## SUBMITTAL RESPONSE

PROJECT NAME : PSE OTC

Item :	Joist & Metal Deck Shop Drawings
--------	----------------------------------

**PSE TRAINING CENTER PUYALLUP**  
 PUYALLUP, WA  
 PENNON CONSTRUCTION COMPANY INC.  
 GENERAL CONTRACTOR  
 SEI JOB NO: 43423

**S2.03**

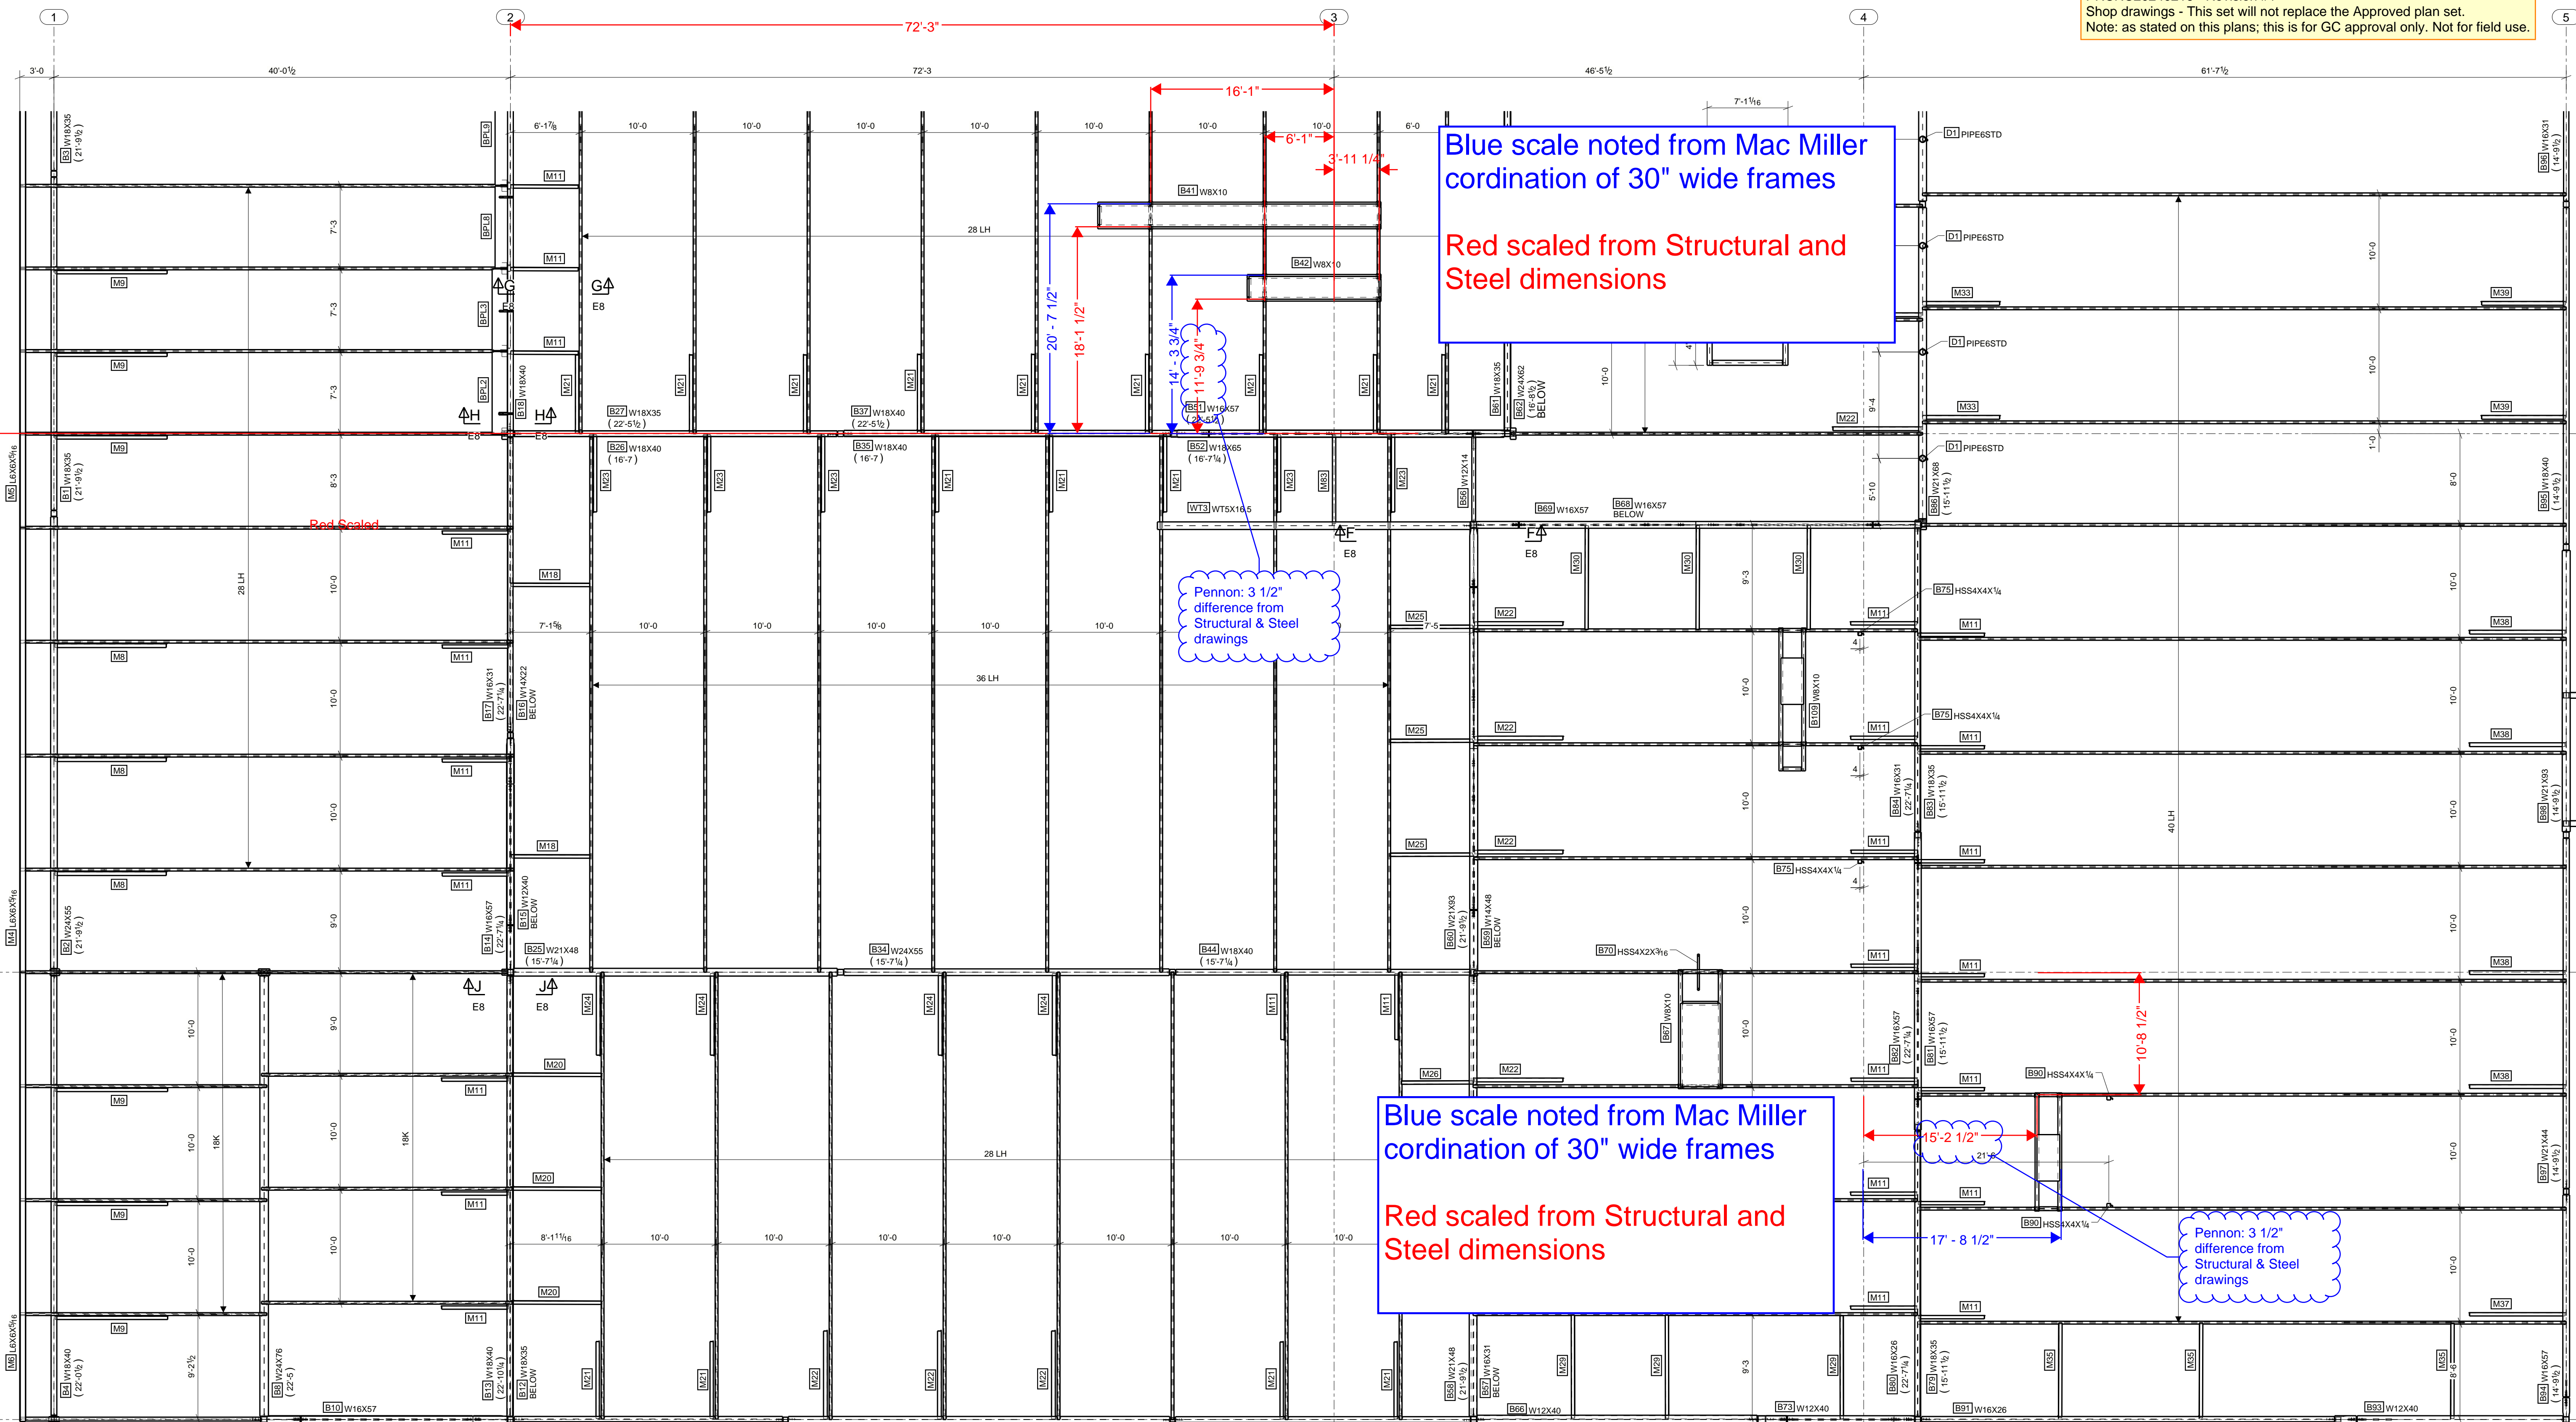
Pennon: 3 1/2" difference from Structural & Steel drawings

**1 Level 01 - SHEETMETAL - SECTOR A**  
 SCALE: 1/8" = 1'-0"

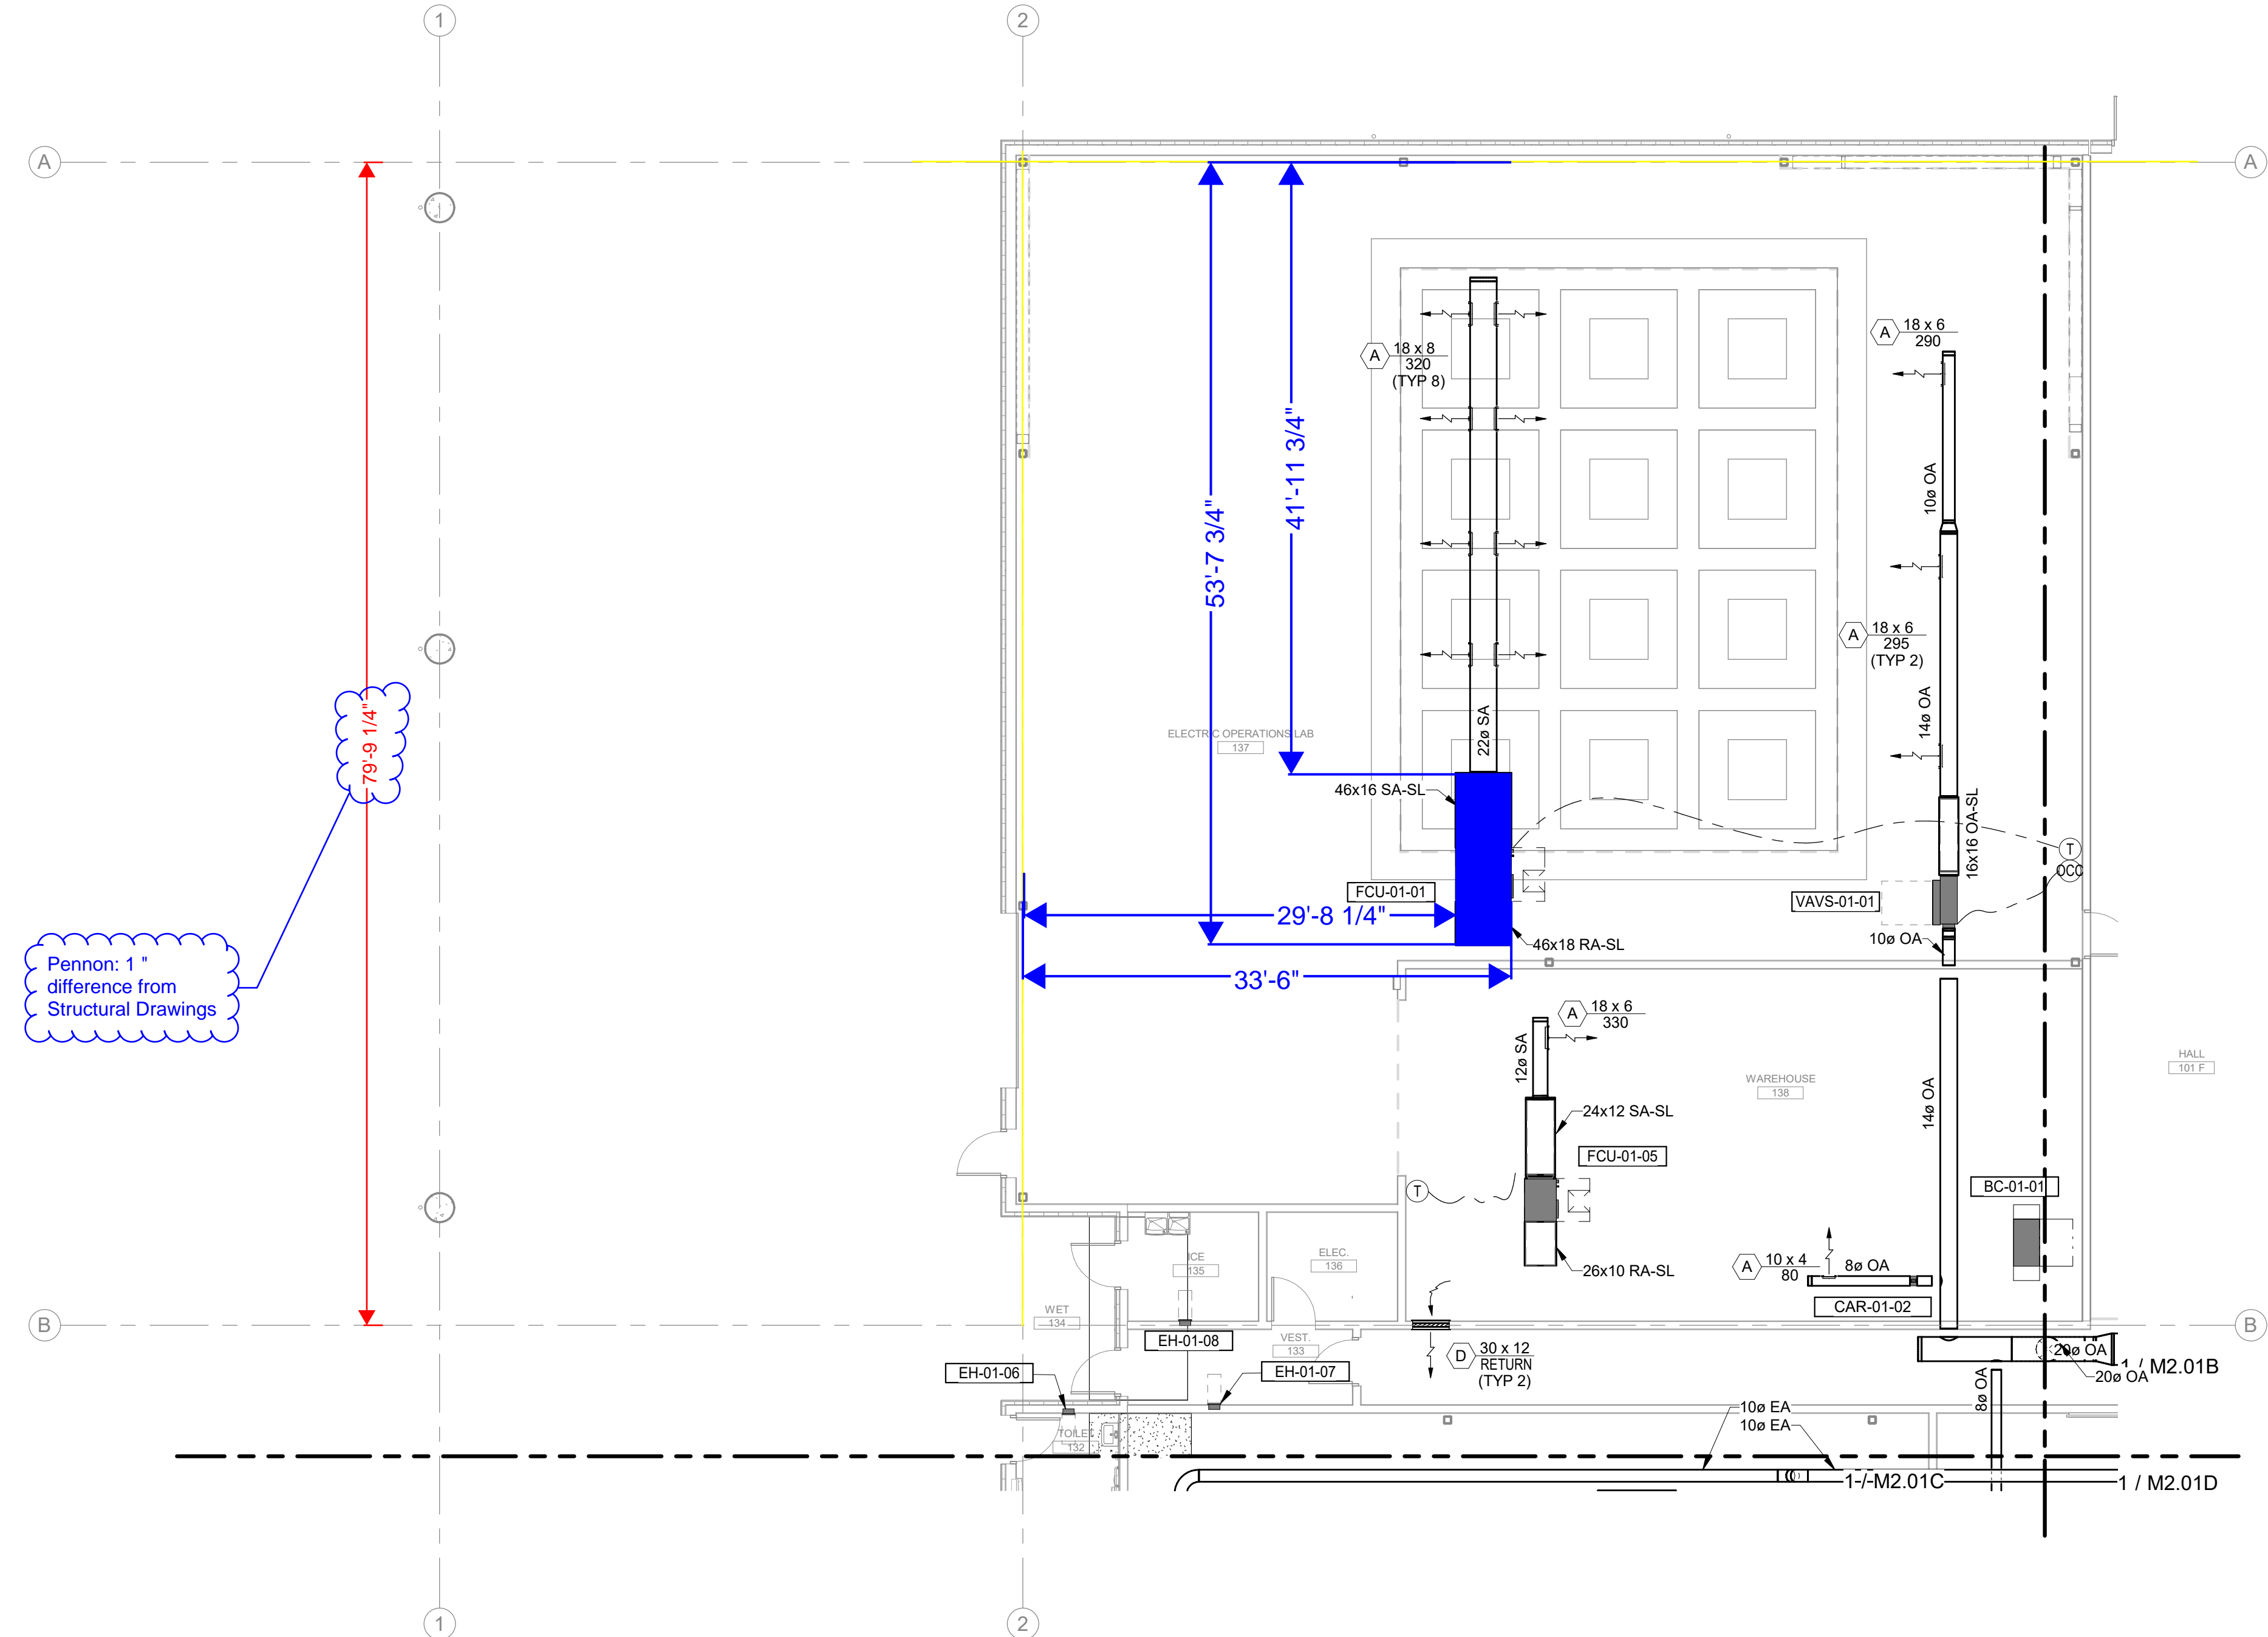
Pennon: 1" difference from Structural Drawings

**3 Level 01 - SHEETMETAL - SECTOR C**  
SCALE: 1/8" = 1'-0"

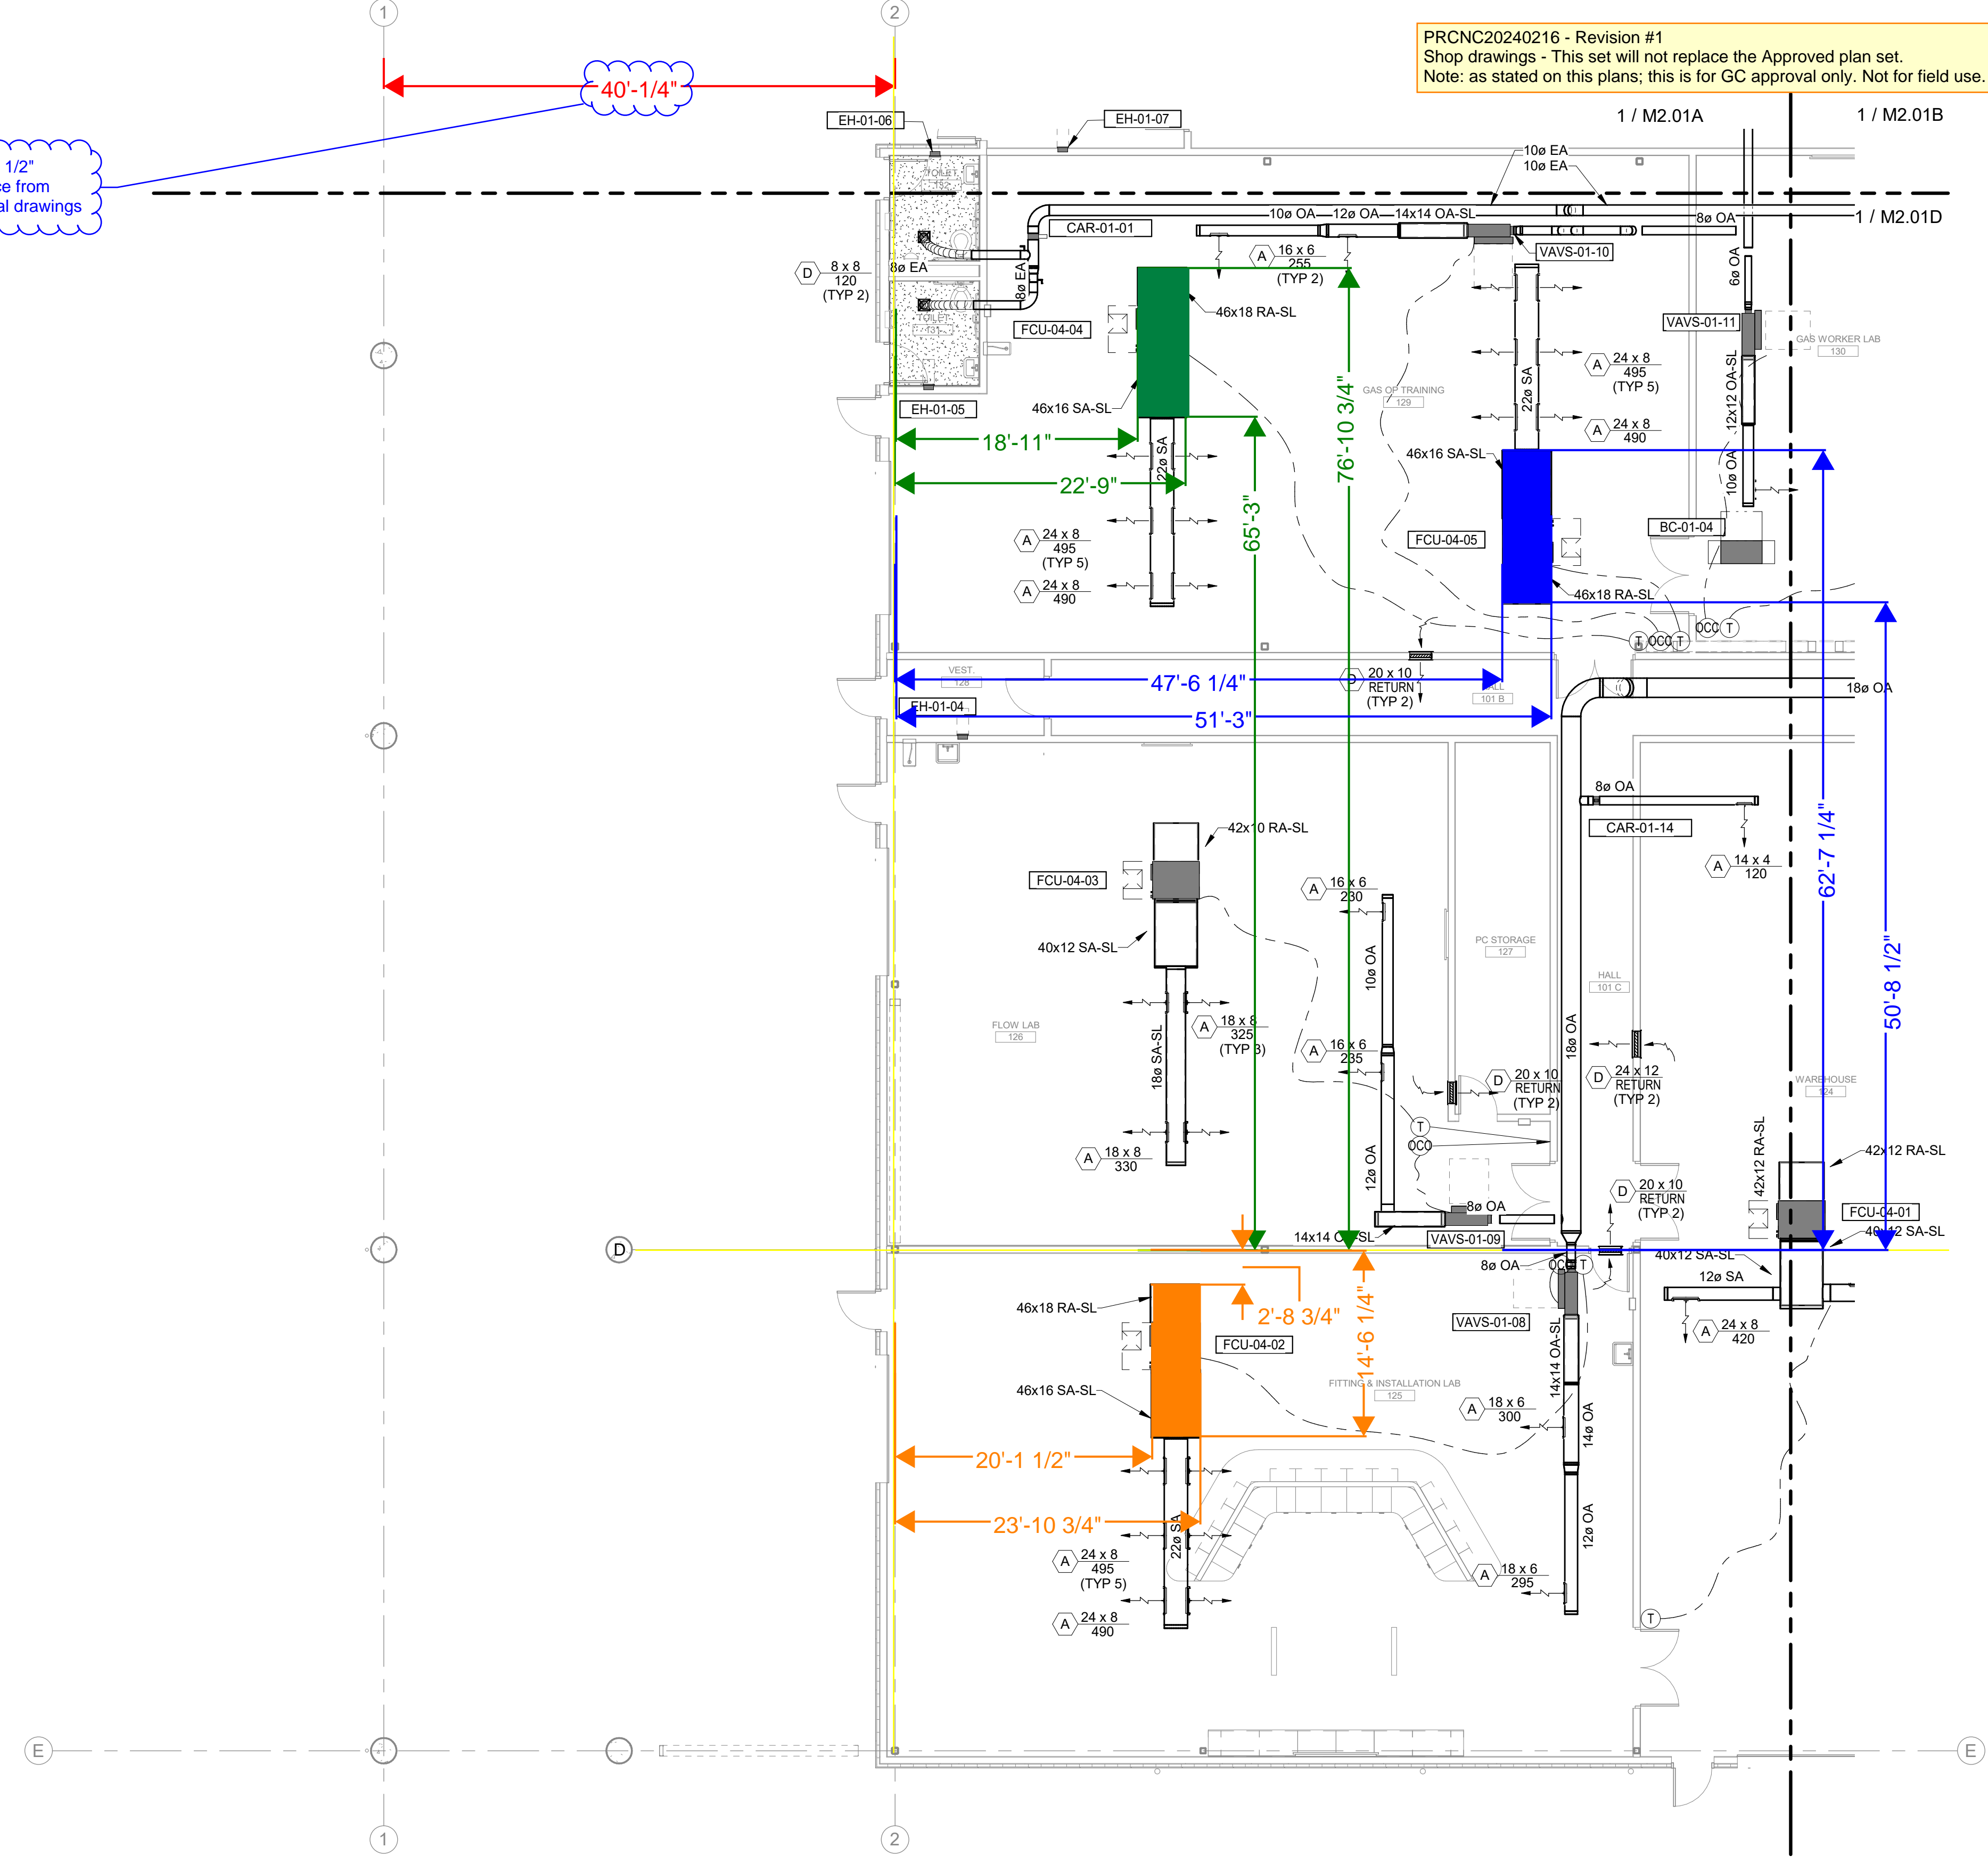
Pennon: 1/2" difference from Structural drawings
